RE: Status Update on the Discharge Permit Application for the Los Alamos National Laboratory, Radioactive Liquid Waste Treatment Facility, DP-1132

**SUBJECT: REQUEST FOR ADDITIONAL INFORMATION, DP-1132, RADIOACTIVE
LIQUID WASTE TREATMENT FACILITY**

Subject: Revised Closure Plan and Draft Permit Comments, DP-1132

Closure Plan

Figure 1. Aerial View Radioactive Liquid Waste Treatment Facility

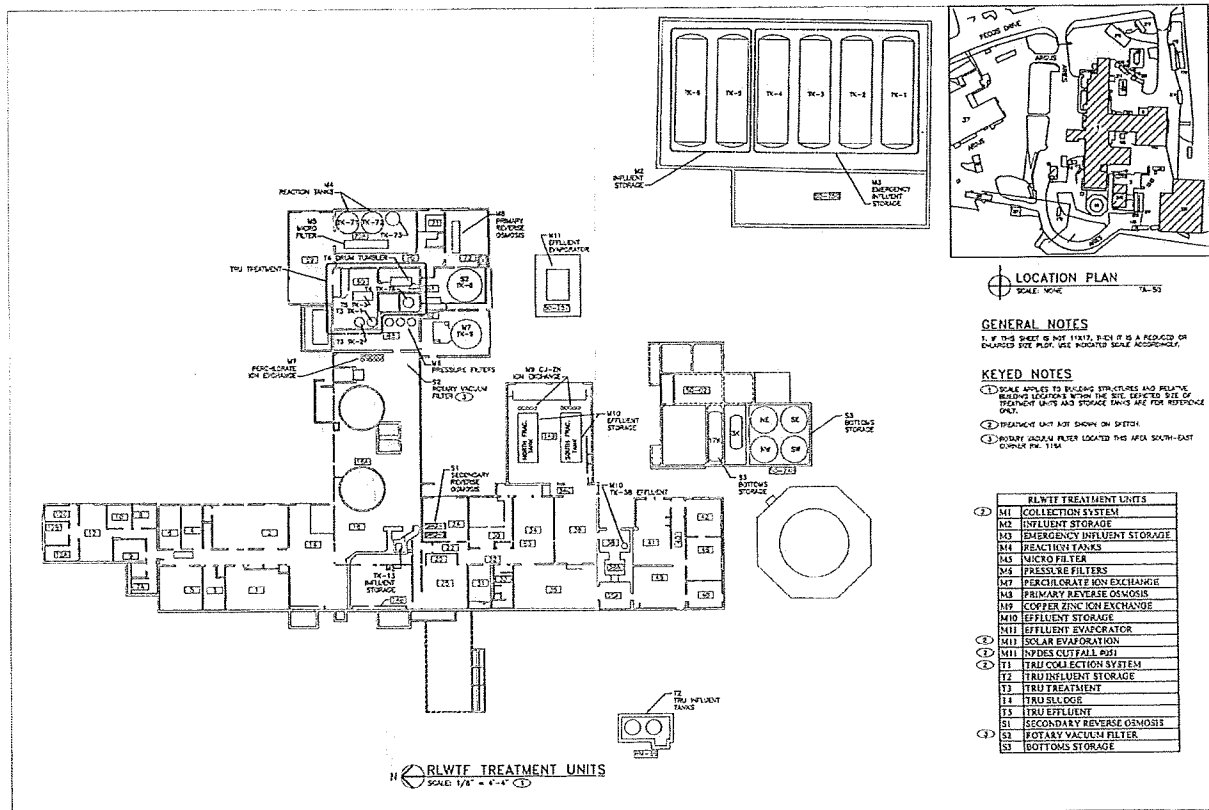
| No. | Section # | Page # | Description of Change |
|-----|-----------|--------|--|
| 22 | Figure 1 | 60 | Each of the major buildings in the aerial photograph were labeled with the building name and number. |

Figure 4. Integrated RLWTF Closure Schedule

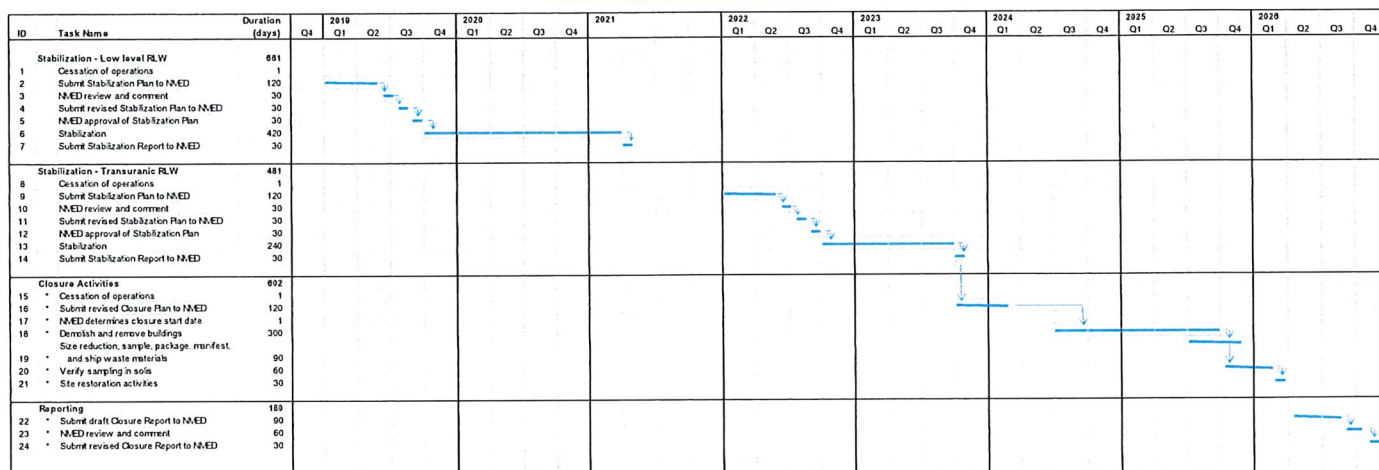
| No. | Section # | Page # | Description of Change |
|-----|-----------|--------|--|
| 23 | Figure 4 | 63 | A title was added to Figure 4. Construction of the proposed TLW Facility was added to timeline. |
